Access Compliance Report

Public Rights-of-Way

(Curb Ramps)

Intersection ID: 13531	Main Street: REMOUNT_RD	Cross Street: WEST_BV	Location: NW
ADA ID: 69C55E76AF80	Ramp Type: PerpDiag	Initial Pass/Fail: Pass	Overall Compliance: No
			Severity Score: 12.75

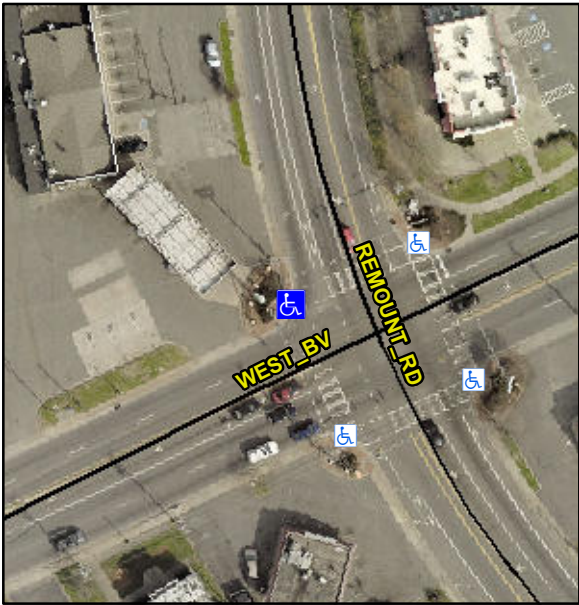
Codes/Mitigation Info/Possible Solution			Field Measurements/Component Compliance							
	Possible Solutions:		Compliance			Description			Data	
	Remove & Replace Curb Ramp With Two New Directional Ramps or Equivalent.		N/A	Ramp Length (in)	37.0	Yes	Ramp Slope (%)	6.8		
			Yes	Ramp Width (in)	57.0	No	Ramp XSlope (%)	4.0		
			N/A	Flare Type LT	Sloped	N/A	Flare Type RT	N/A		
			N/A	Flare Slope LT (%)	4.5	No	Flare Slope RT (%)	11.6		
			N/A	Flare Traversable LT?	Yes	N/A	Flare Traversable RT?	Yes		
			Yes	Landing Length (in)	93.0	No	DWS Provided?	No		
			Yes	Landing Width (in)	60.0	N/A	DWS Contrast?	No		
			No	Landing Slope (%)	4.4	N/A	DWS Length (in)	N/A		
			Yes	Landing X Slope (%)	2.8	N/A	DWS Full Width?	No		
<p>Surveyor Notes:</p> <p>N/A</p> <p>PROW/ADA:</p> <p>R304.5.3, R304.2.2-Perp, R304.3.2-Para, R304.2.3, R305</p>				N/A	Landing Curb? (Y/N)	No	N/A	DWS Offset (in)	N/A	
				N/A	Shared Landing?	No

Yes	Gutter Ponding?	No	Yes	Gutter Slope (%)	0.3	
				Yes	Gutter Lip Ht (in)	0.0	Yes	Gutter X Slope (%)	2.6	
				N/A	Painted X Walk1?	Yes	N/A	Painted X Walk2?	Yes	
					X Walk 1 Direction	To S		X Walk 2 Direction	To E	
				N/A	X Walk 1 Width (in)	107.0	N/A	X Walk 2 Width (in)	111.0	
					X Walk 1 Slope (%)	0.5		X Walk 2 Slope (%)	2.1	
					X Walk 1 X Slope (%)	1.6		X Walk 2 X Slope (%)	0.7	
				Yes	Ramp inside XWalk1?	Yes	Yes	Ramp inside XWalk2?	Yes	
				Road Slope (%)	2.8	N/A	Clear Space?	Yes		
				Road X Slope (%)	1.6	Yes	Clear Space to XWalk (in)	64.0		
			Yes	Any Obstructions?	No	Yes	Storm Grate/Utility Hazard?	No		
				Obstruction Type			Storm Grate/Utility Type			
						N/A		N/A		
						Yes	Surface Condition? (G/P)	Good		
Total Cost:			\$	3200.00
